Cross River Rail project

Coordinator-General's change report – no. 9

April 2021

Figure 3.1 Southern Portal Area work zones

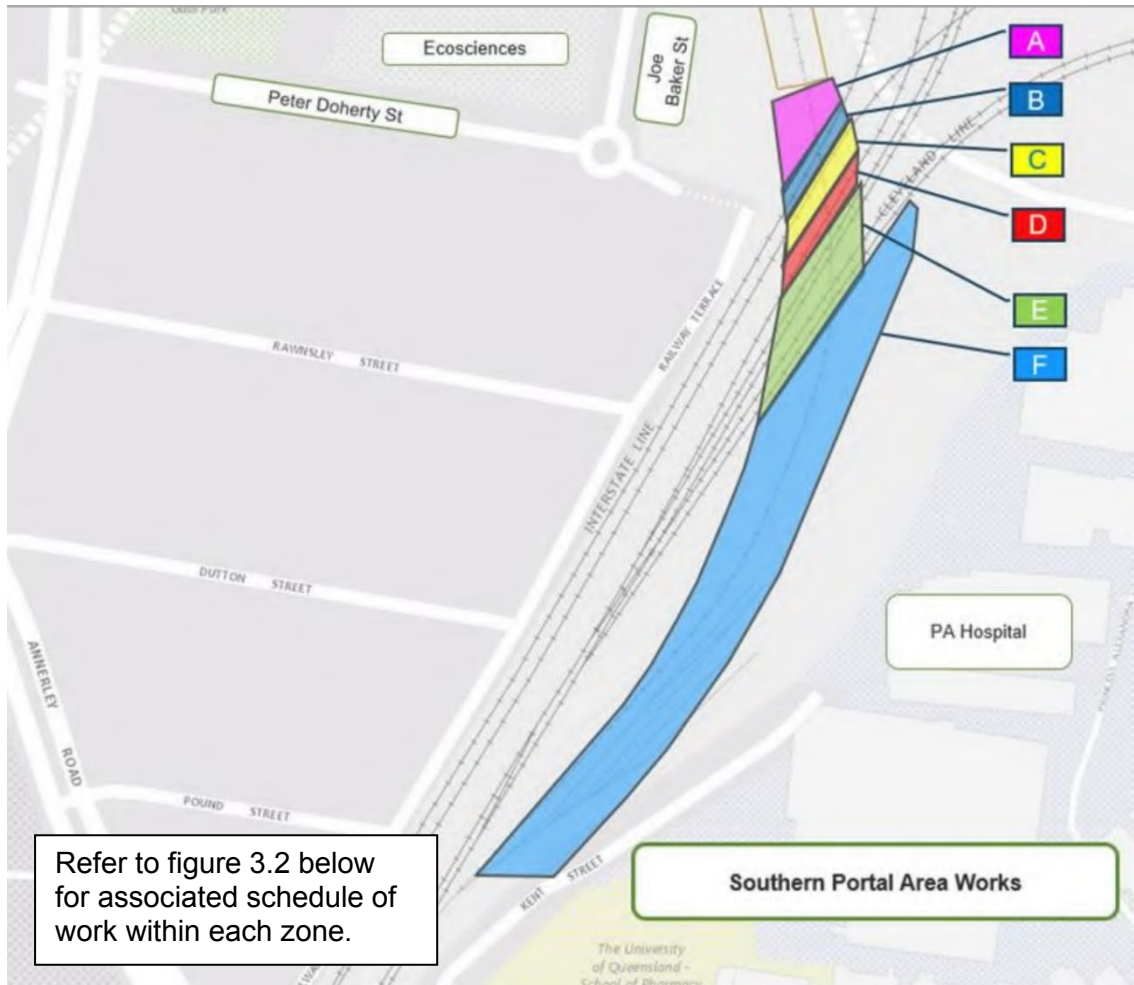
The CRR Delivery Authority requested a new heavy vehicle access route to facilitate construction activities at the Southern Portal Area (see Figure 3.1). The proposed access route was to allow up to ten heavy vehicles per hour to access the site from Peter Doherty Street via a right hand turn movement from Annerley Road. This proposal would require a temporary intersection upgrade at the juncture of Annerley Road and Peter Doherty Street.

Submitters, including BCC, local government elected representatives, a State Member of Parliament and private submitters, raised significant concerns about the proposed heavy vehicle access route citing safety issues for cyclist and pedestrians.

BCC advised that the requested change would result in a significant increase of safety risk to cyclists on Annerley Road and the new heavy vehicle haulage route would not be supported. Submitters also raised concerns regarding:

In response to submissions and in consultation with Brisbane City Council, the CRR Delivery Authority is no longer proposing the new heavy vehicle access route via Peter Doherty Street (off Annerley Road). Instead, the existing Boggo Road haul route is proposed to be utilised for the worksite with mitigation measures to enhance pedestrian and cyclist safety.

Figure 4.3 Extent of noise impact for Southern Portal Area works during Stage 2 rail possession period

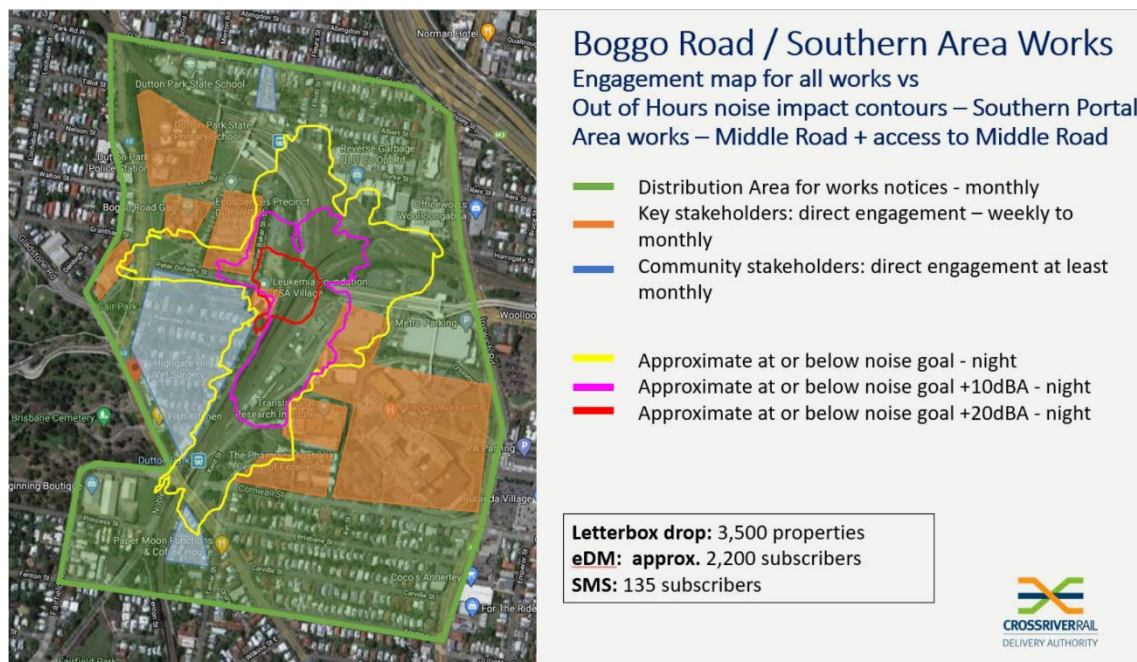
Figure 4.3 below illustrates the modelled noise impact contours predicted during the Stage 2 rail possession period for night-time construction works. As shown, the extent of predicted noise levels at or above the CNGs is generally confined within the existing rail corridor and along Peter Doherty Street, with a small number of residential receivers impacted where CNGs would be exceeded.

As shown in Figure 4.3 above, the extent of stakeholder consultation and engagement to be undertaken is determined by predictive noise modelling. The CRR Delivery Authority reports that sensitive receivers likely to experience sleep disturbance (exceedance of the CNGs by 5 dB(A) or more) will be proactively identified and consulted prior to the commencement of Project Works. It is noted that predicted noise levels in the CNIA are worst-case and are subject to the implementation of the construction program, effectiveness of mitigation measures and actual façade reductions experienced in practice.

In instances when predicted or monitored noise levels are found to be above the relevant CNG (daytime or night-time goals), the CRR Delivery Authority must proactively engage with DAPs and develop tailored mitigation measures on a 'case by case' basis with them. The CRR Delivery Authority must maintain records of engagement with DAPs and add any agreed mitigation measures in the project's mitigation register.
